CERTIFICATE OF APPROPRIATENESS

Property: 3803 Bute Street, Lot 8, Tracts 1, 6A and 6B and W ½ of Lot 9, block 10, Bute Subdivision. The property includes a 6,560 square foot one and two-story brick commercial building situated on a 14,375 square foot corner lot.

Proposal: Alteration – Replace an existing loading dock door with a tri-part storefront, made up of a single lite entry door and single lite side lites. The existing opening measures 10'-2" wide and 9'-2" in height; the opening will not be modified.

WEST ELEVATION – FRONT FACING BUTE STREET

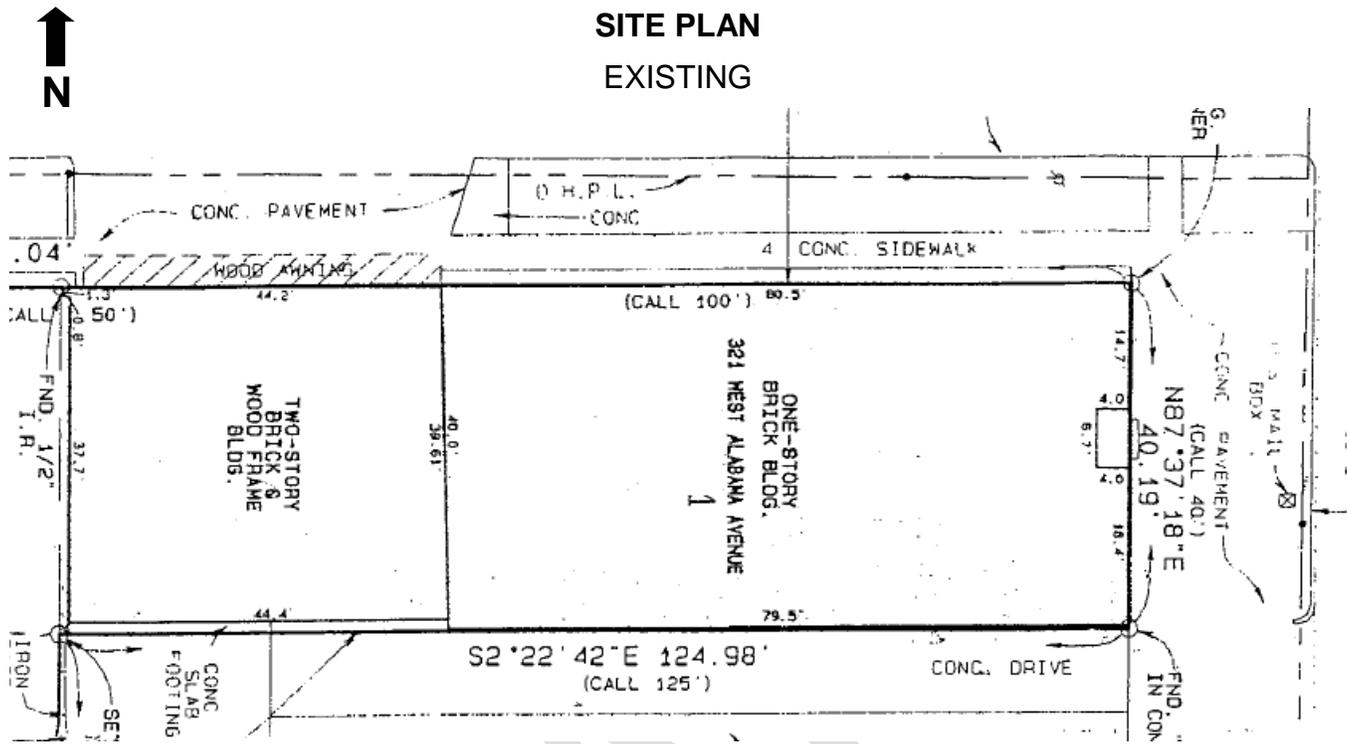
Recommendation: Approval
